ADDENDUM No. 3
Request for Competitive Sealed Proposals (CSP)
19CSP067 HVAC and Electrical Improvements at Hill
Elementary School

ADDENDUM NUMBER 3

Project: **HVAC and Electrical Upgrades at
Hill Elementary School
Austin Independent School District
PROJECT NO. 19CSP067 (19-0021-HILL)**

SHEET NO.
E201

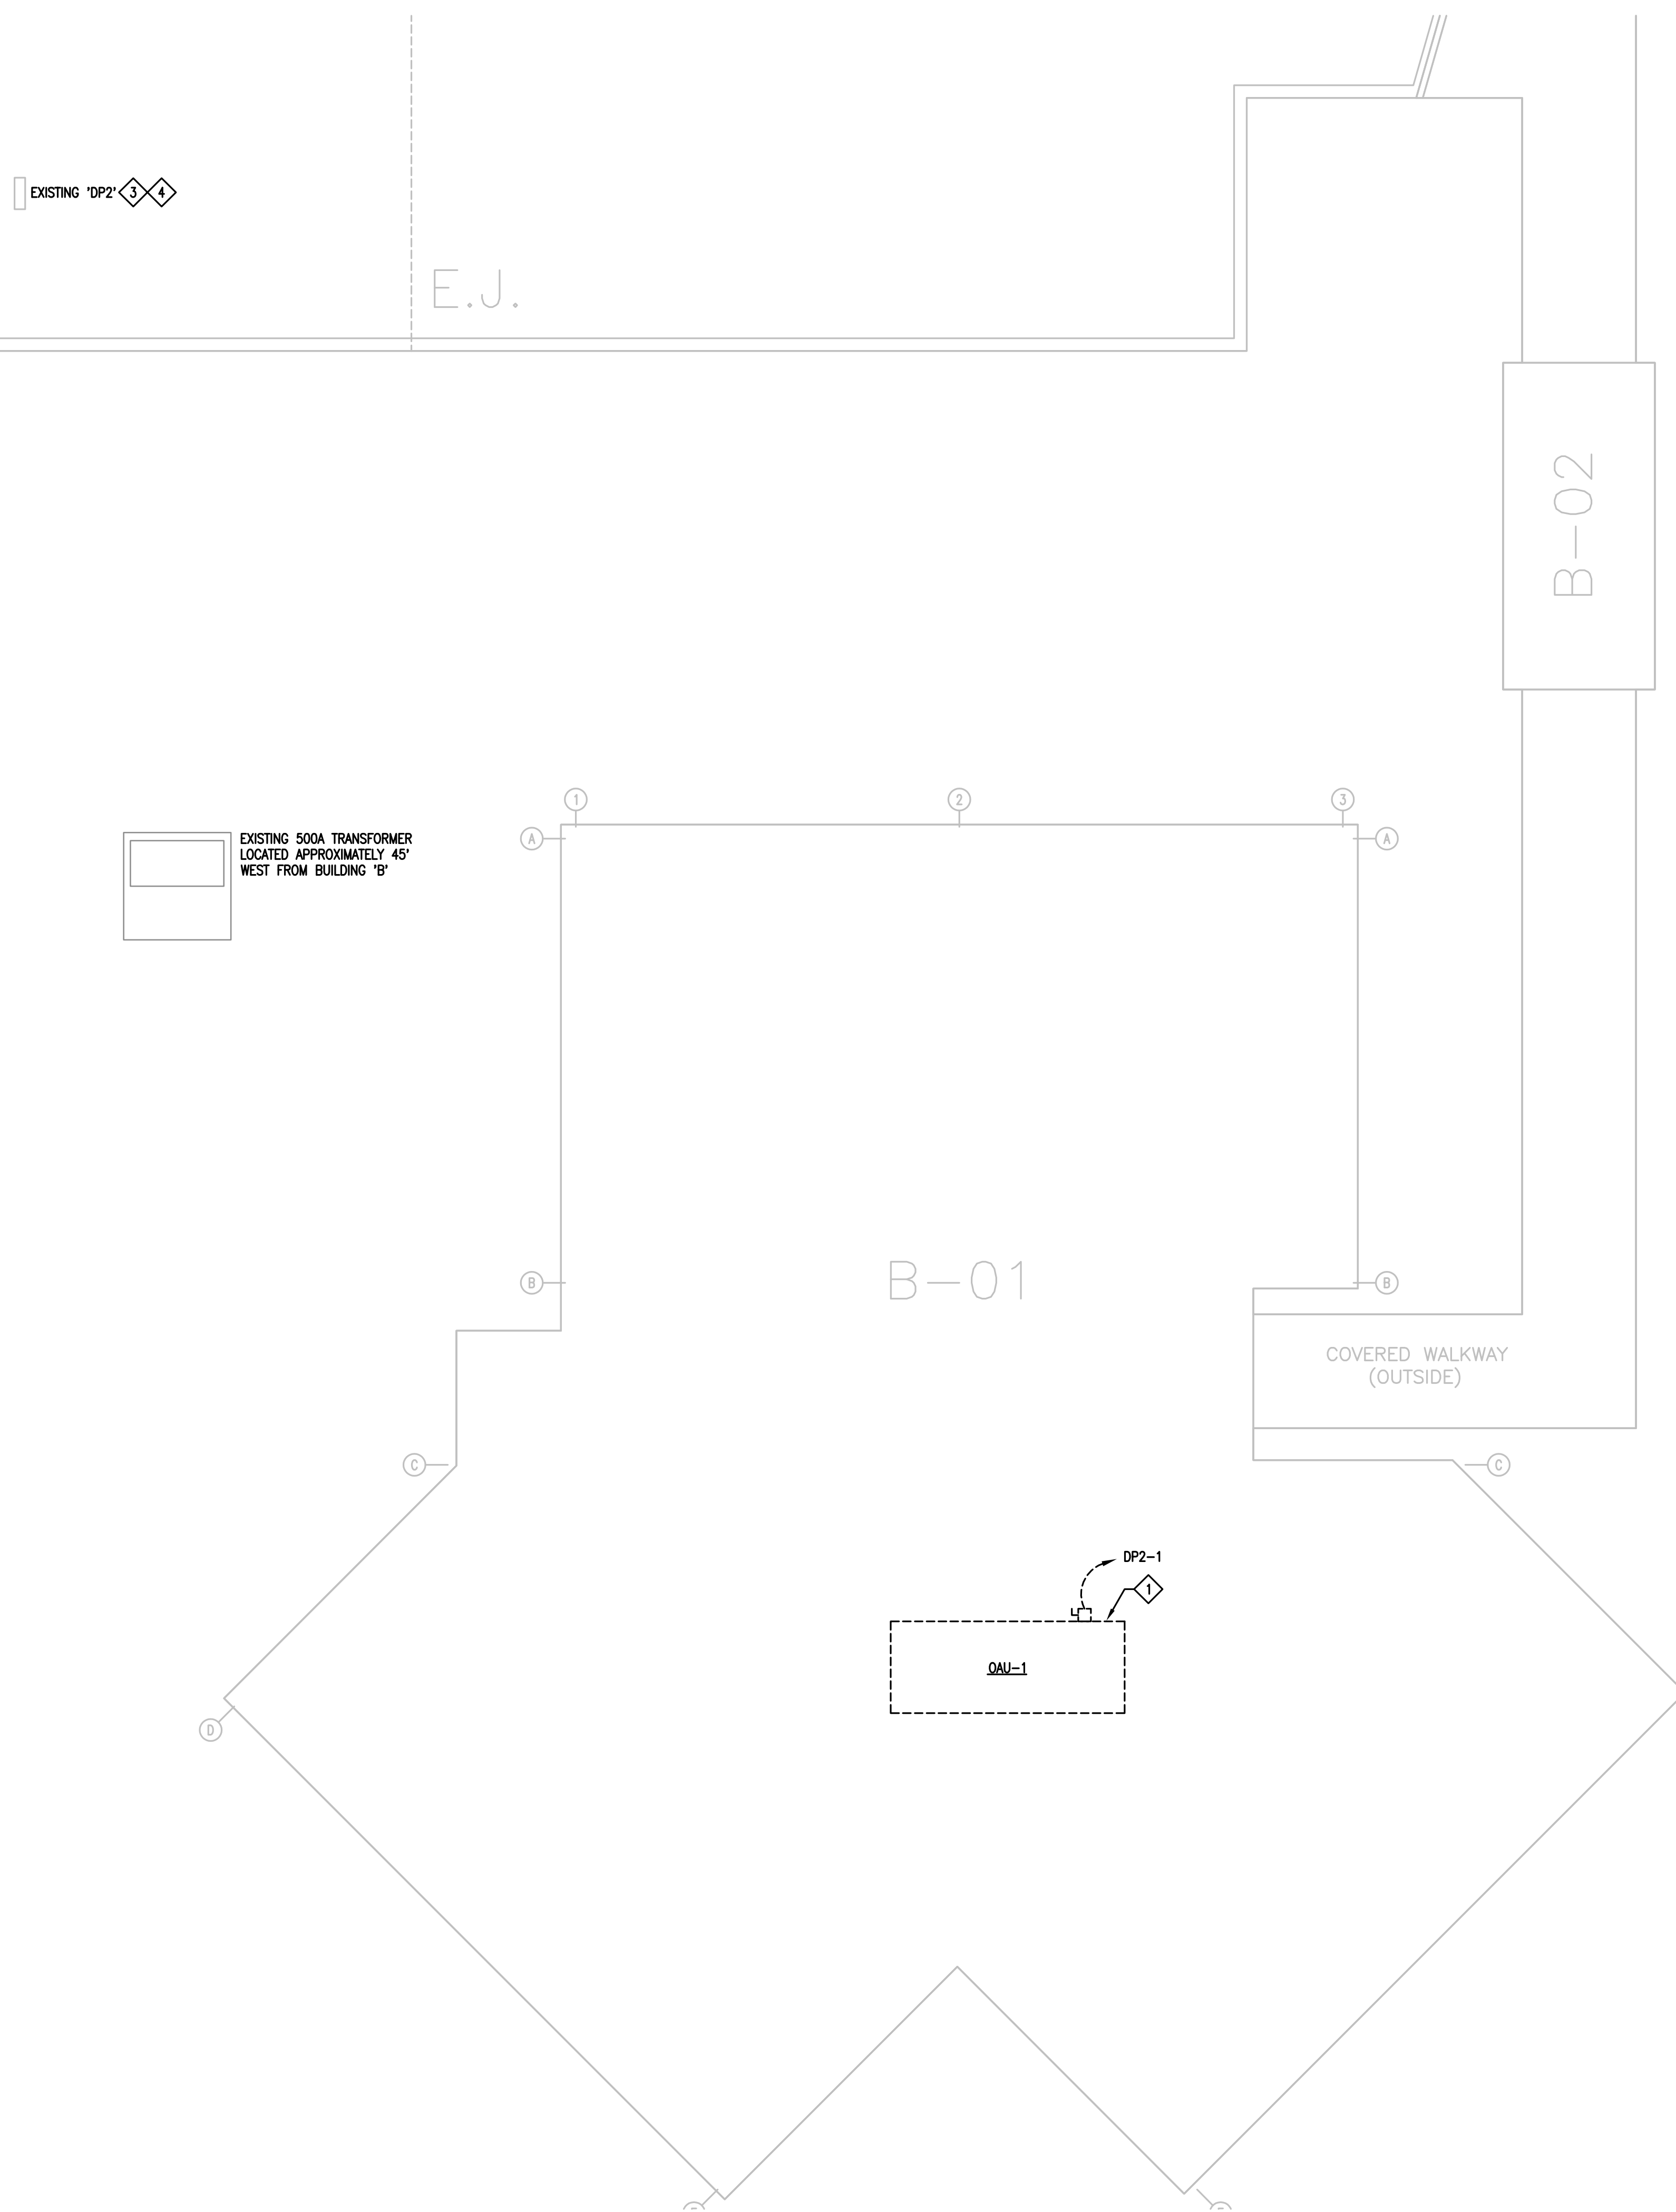
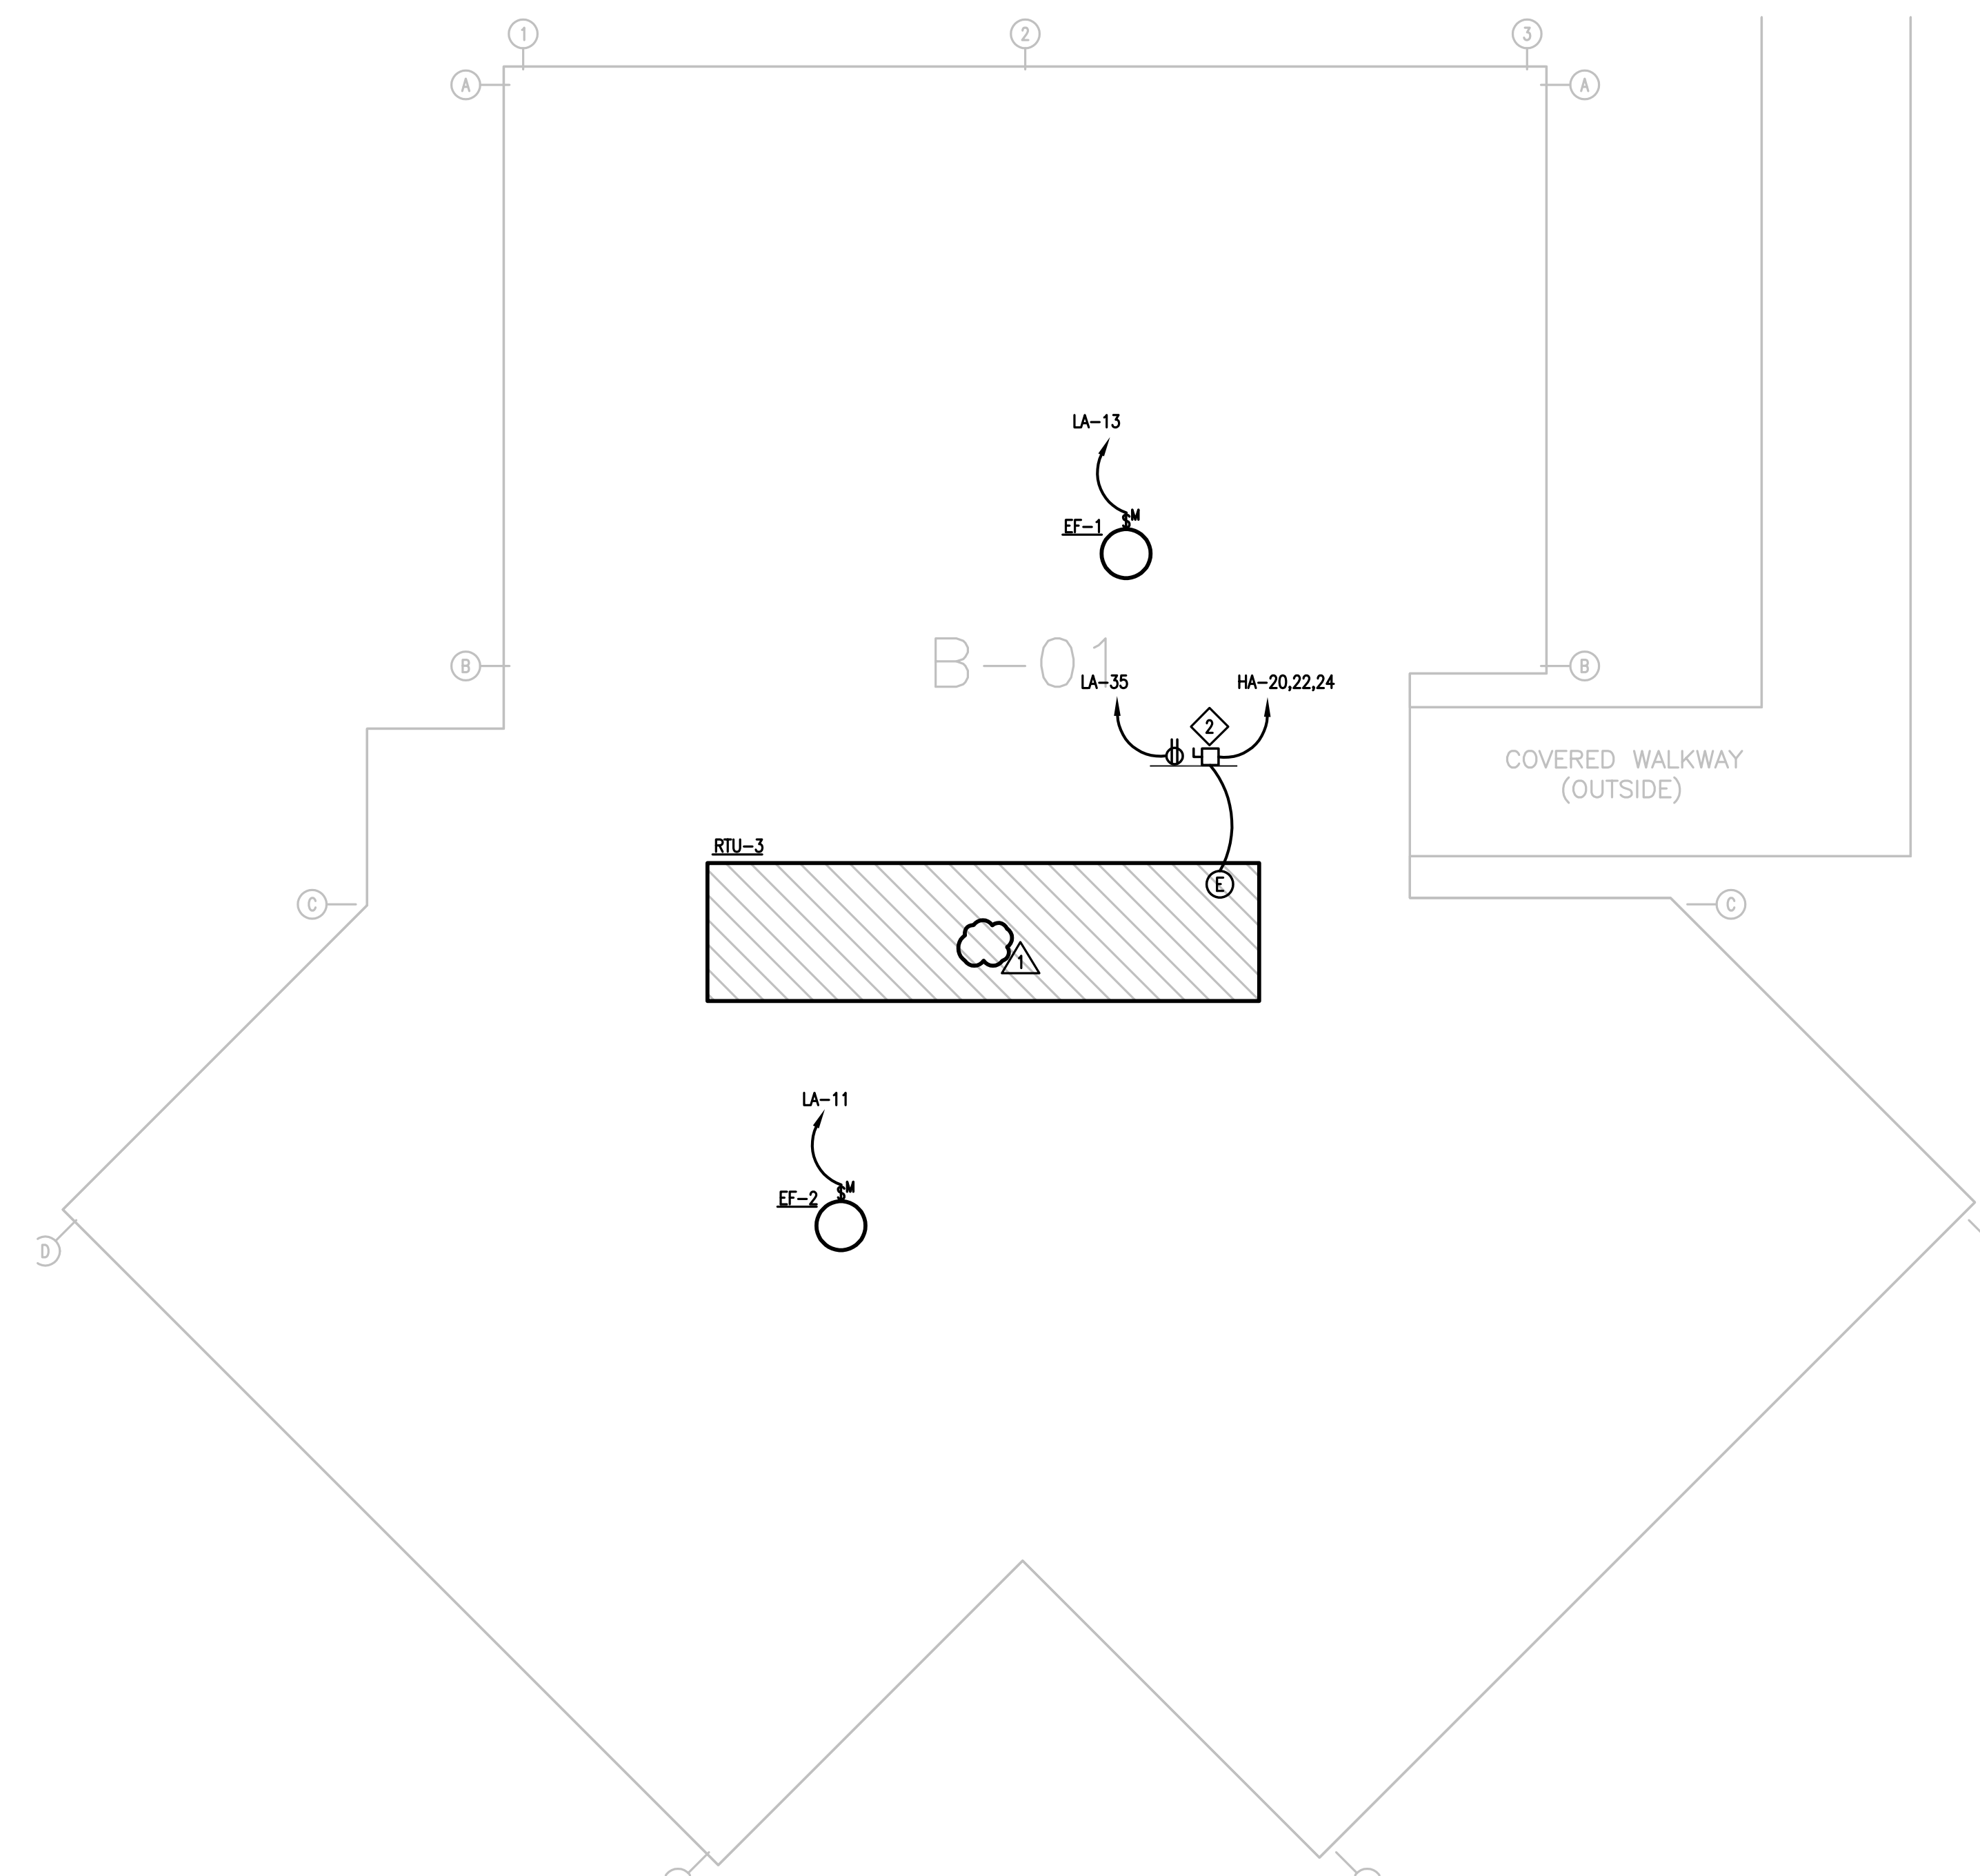
Sheet E201 – Roof Plan Electrical

- a. Delete duct detector shown for RTU-3.

SHEET NO.
M301

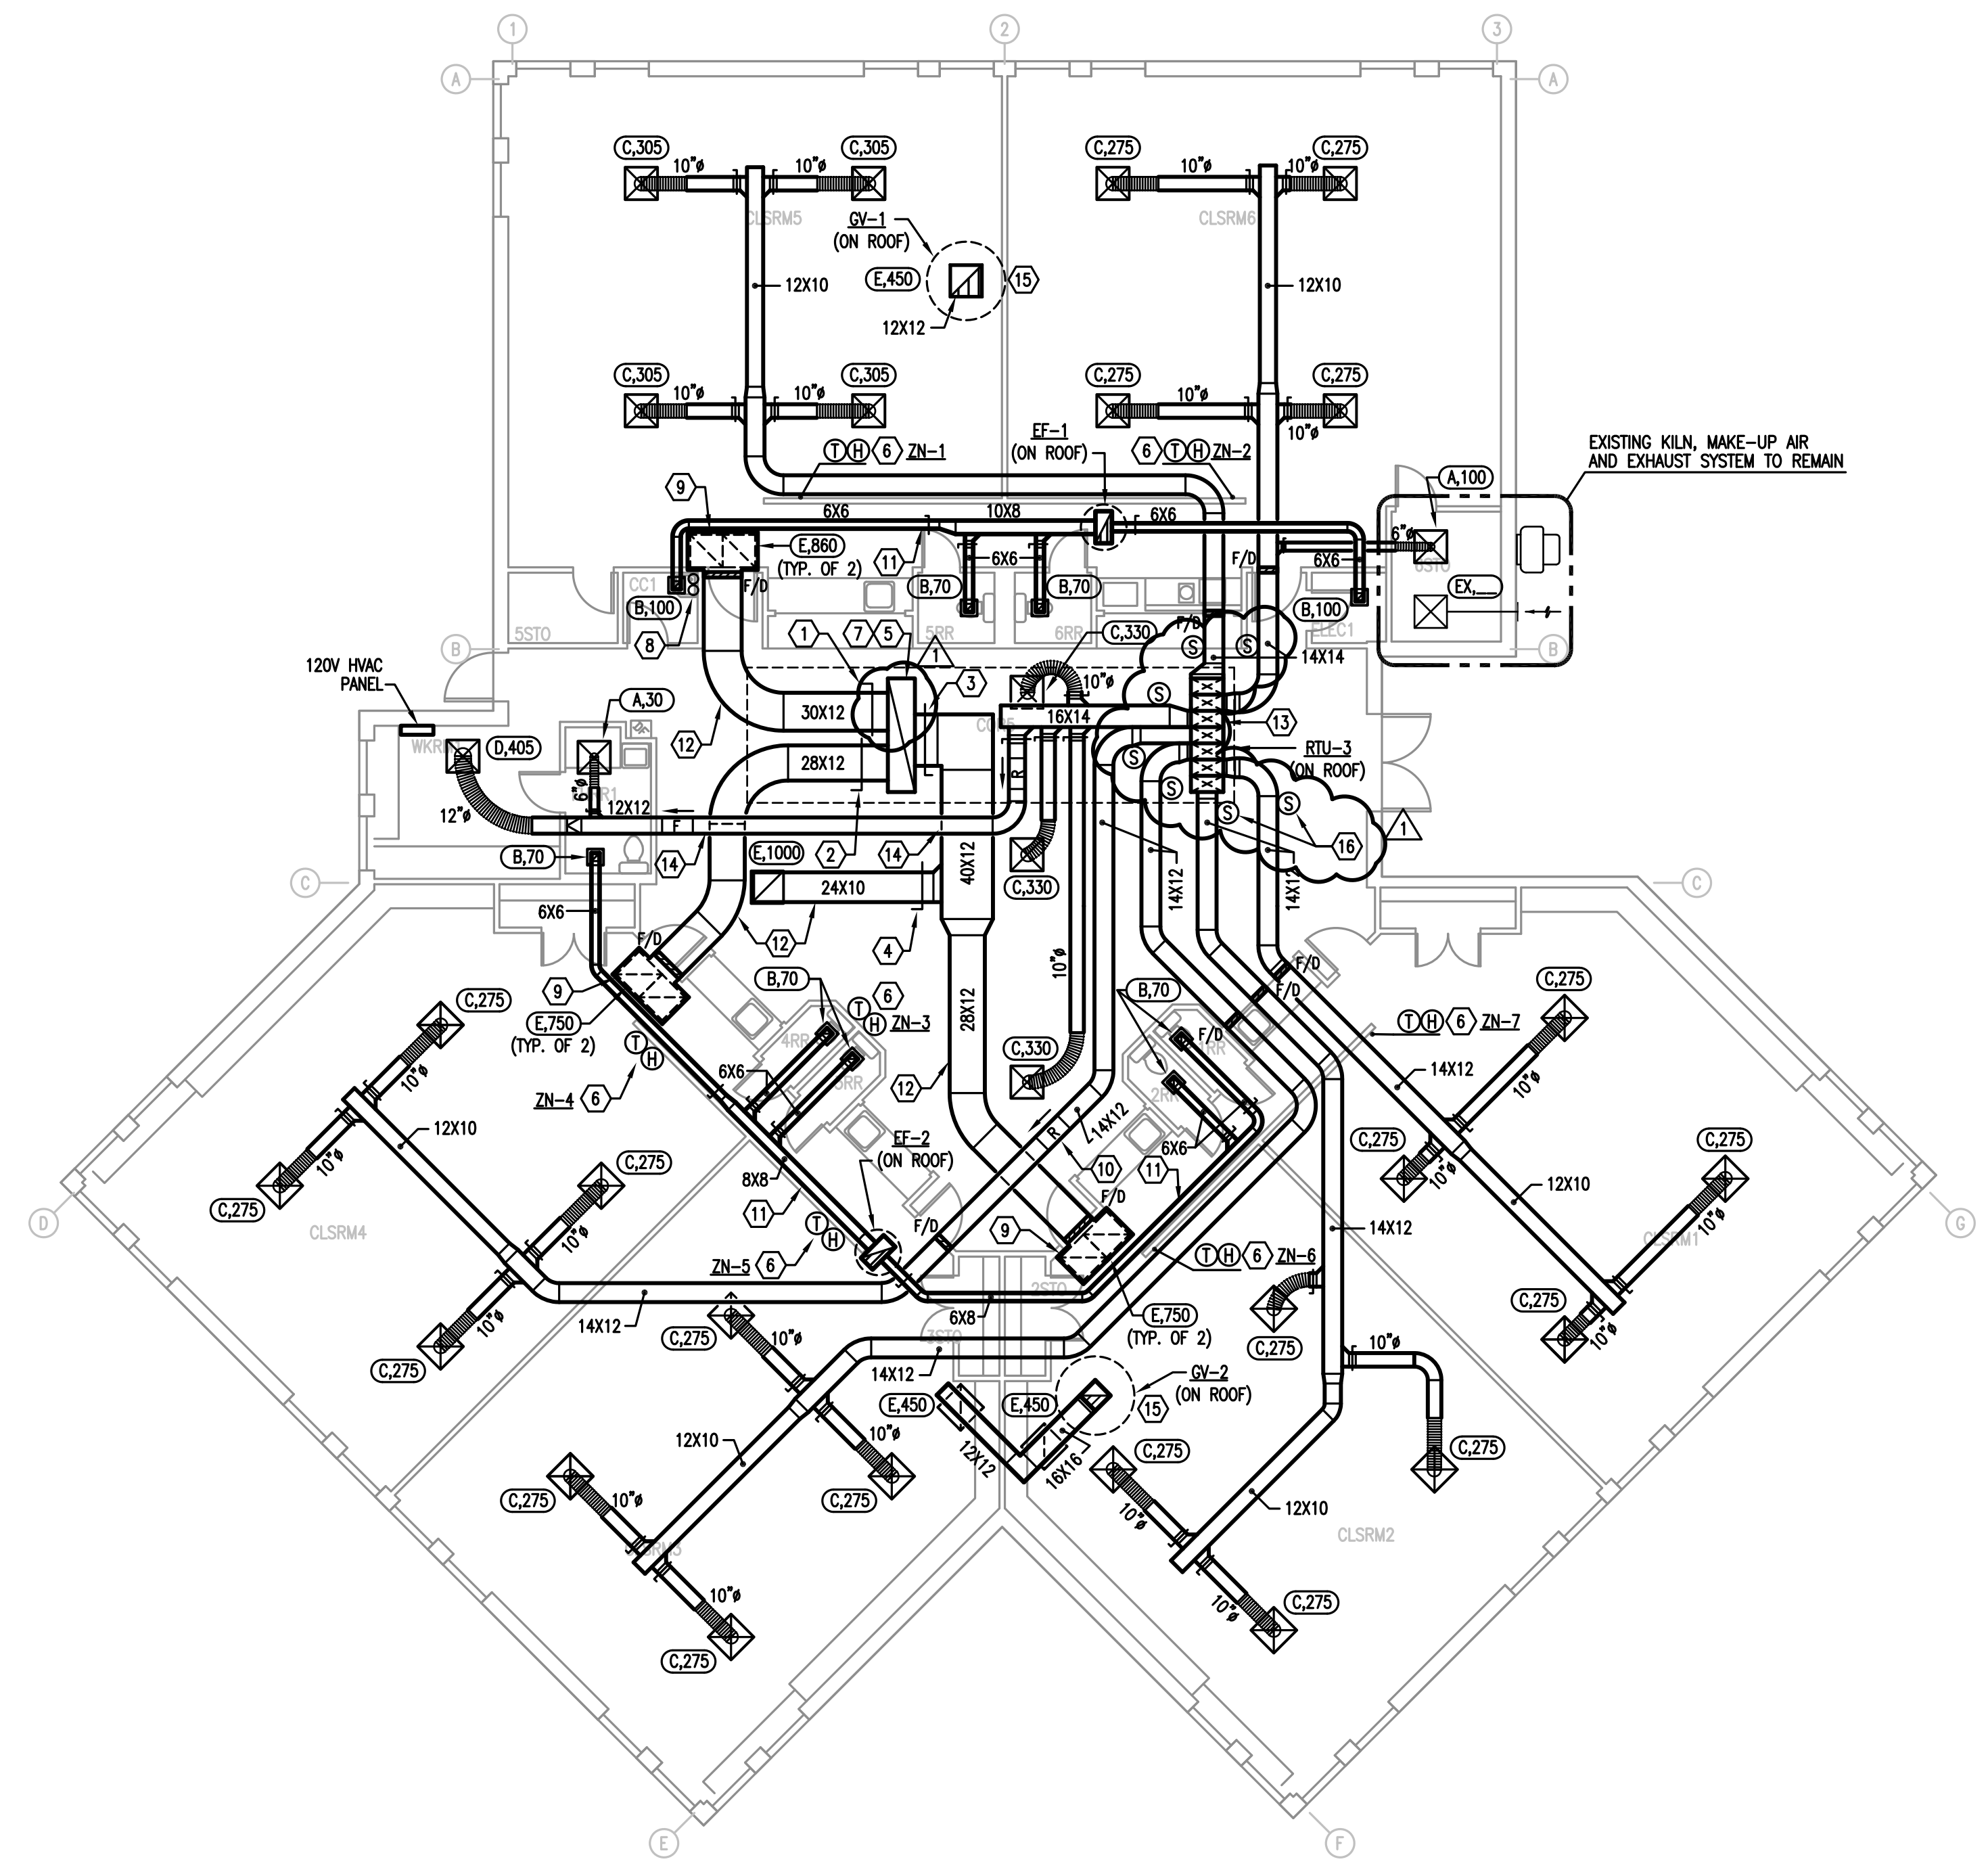
Question 1: The duct detector on M301 is shown on the Return Side of RTU-3. The Fire Marshal requires that the duct detection be installed on the Supply side of units. Please verify if the duct detector should be installed on the supply side.

Question 2: If the detector is to be installed on the supply side, please verify if a single detector can be installed or if (7) duct detectors will be required to cover each supply zone.

Sheet M301 – Floor Plan Mechanical

- a. Remove smoke detector in return ductwork.
- b. Add smoke detector in supply duct for each zone.

Response: The detector will be removed from the return and added to supply side for each zone. Refer to attached drawings M301 and E101.

Response: A total of (7) detectors shall be installed. Refer to attached drawings M301 and E101.

- TRANSITION RELIEF AIR DUCT FROM RETURN AIR GRILLES TO GRAVITY VENTILATORS LOCATED ON ROOF.
 - INSTALL SMOKE DETECTOR IS SUPPLY DUCTWORK. TYPICAL.
